QUALITY ASSURANCE -- NON-CONFORMANCE REPORT

Location: Changxing Island, Shanghai, PRC **Report No:** NCR-000427
Prime Contractor: American Bridge/Fluor Enterprises, a JV **Date:** 22-Sep-2009
Submitting Contractor: Zhenhua Port Machinery Company, Ltd (ZPMC), Changxing Island **NCR #:** ZPMC-0401

Reference Description: Missed MT indications on West Tower, Lift 1, 43m Diaphragm to CD Diagonal Stiffener weld

To:	AMERICAN BRIDGE/FLUOR, A JV 375 BURMA ROAD OAKLAND CA 95607	Date:	23-Sep-2009
Dear:	Mr. Charles Kanapicki	Contract No:	04-0120F4 04-SF-80-13.2 / 13.9
Attention:	Mr. Thomas Nilsson Project/Fabrication Manager	Job Name:	SAS Superstructure
Subject:	NCR No. ZPMC-0401	Document No:	05.03.06-000387

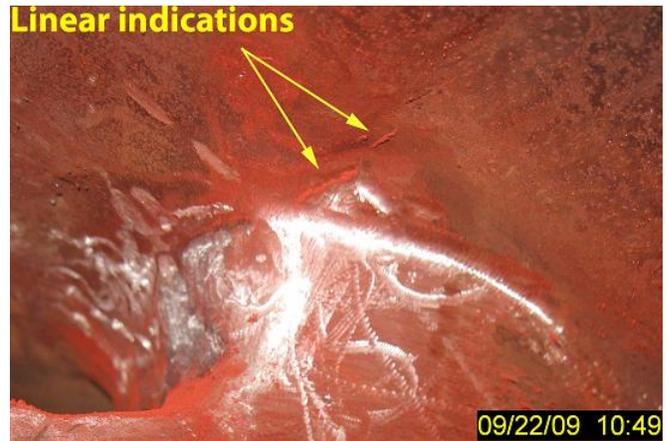
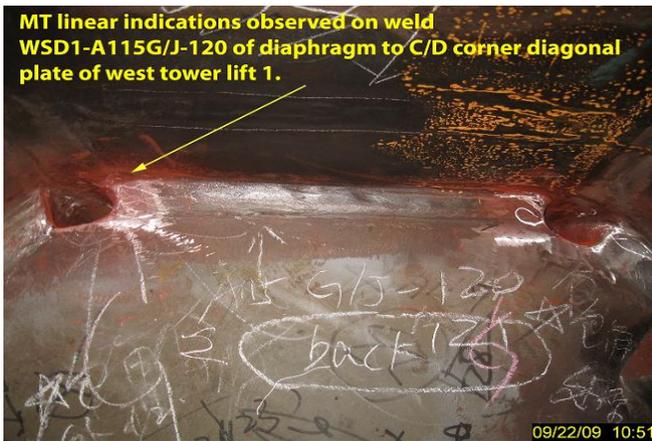
During Magnetic Particle Testing (MT) of West Tower, Lift 1, 43m diaphragm to C/D corner diagonal stiffener weld WSD1-A115G/J-120, QA observed two (2) transverse linear indications of approximately 12mm and 4mm in length. This weld had been previously tested and accepted by ZPMC Quality Control personnel.

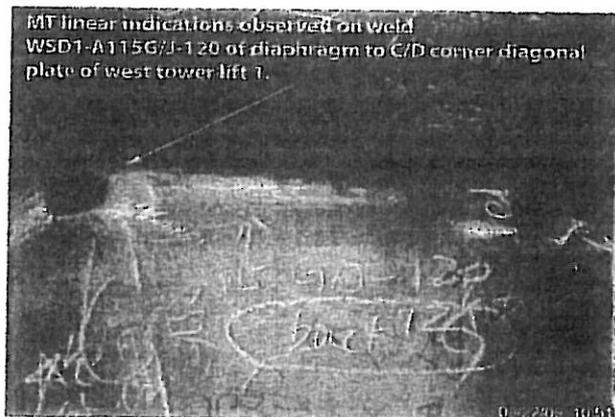
During Magnetic Particle Testing (MT) of West Tower, Lift 1, 43m diaphragm to C/D corner diagonal stiffener weld WSD1-A115G/J-120, QA observed two (2) transverse linear indications of approximately 12mm and 4mm in length. This weld had been previously tested and accepted by ZPMC Quality Control personnel.

WSD1-A115G/J-120

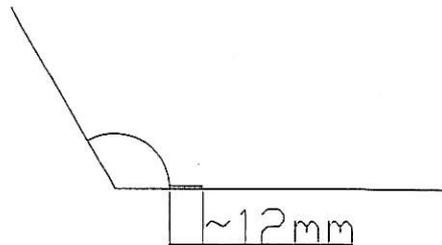
西塔第一吊装段43M隔板位置处CD角发现一线性缺陷，长约12MM，如图：

The linear defect was found at first lifting 43m diaphragm CD corner, 12mm in length, see draft.

1. 火焰加热时, 水汽没有完全的去掉或者这个区域预热不够;
1. Moisture wasn't completely removed during drying operation (preheating) or the area wasn't preheated sufficiently.

1. QC 须监控碳刨、打磨和焊接过程
 2. 碳刨去除缺陷并打磨光滑
 3. VT 检测以确保缺陷被清除
 4. 焊接须符合 WPS 要求
 5. 在进入下道焊缝前, QC 须确保所有焊渣都已被去除干净
 6. 打磨返修区域使其与临近焊缝或母材齐平
 7. 对返修区域进行 VT, MT 和 UT 检测
-
1. QC shall monitor gouging/grinding/welding
 2. Gouge defects & grind smoothly
 3. Verify that defects have been removed with VT
 4. Welding shall be in accordance with WPS
 5. QC shall ensure all slag is removed prior to deposition of subsequent weld passes
 6. Blend repair area with adjacent base metal
 7. Perform VT, MT, & UT to repaired area

1. QC shall verify sufficient preheat has been applied, to remove moisture, prior to welding.
